REMARKS

AMENDMENTS TO THE DRAWING:

Fig. 1

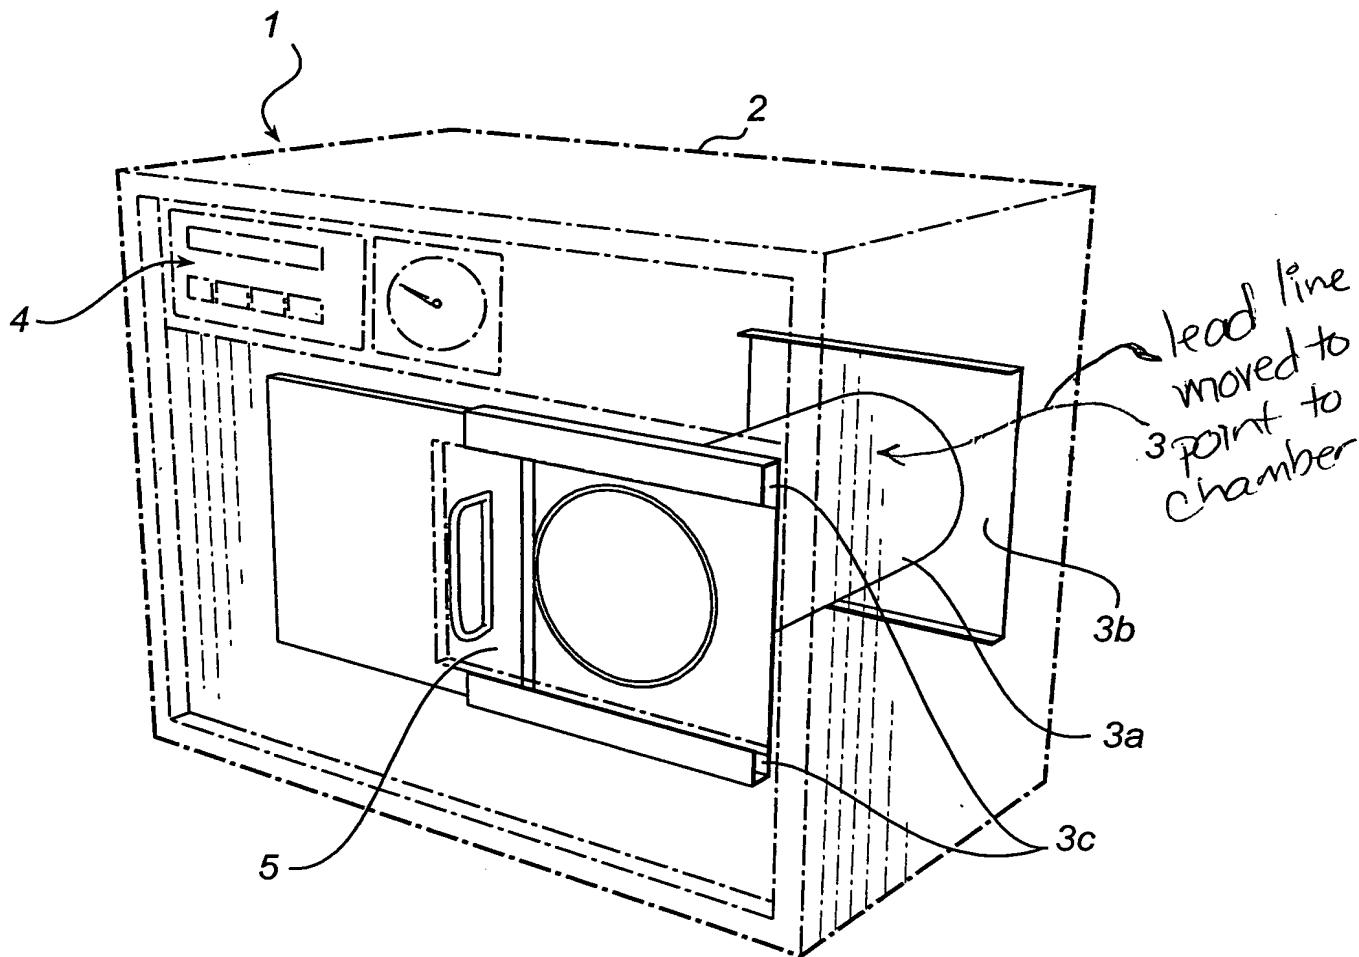
As set forth above, the drawings have been amended such that the lead lines from characters 3 and 3b do not reference the same element. More specifically, the lead line from character 3 references the entire sterilization chamber, and the lead line from character 3b references the back wall of the chamber. Further, as set forth above, claim 1 has been amended to overcome the rejection under Section 112, second paragraph, by clearly describing the sterilization chamber. In view of the above, Applicant respectfully submits that the Examiner's objection to the drawings and the rejection under Section 112 have been obviated.

The attached sheet of drawings includes changes to Fig. 1, such that reference character 3 clearly designates the sterilization chamber, while reference character 3b designates the back wall of the sterilization chamber. This sheet, which includes Fig. 1, replaces the original sheet including Fig. 1.
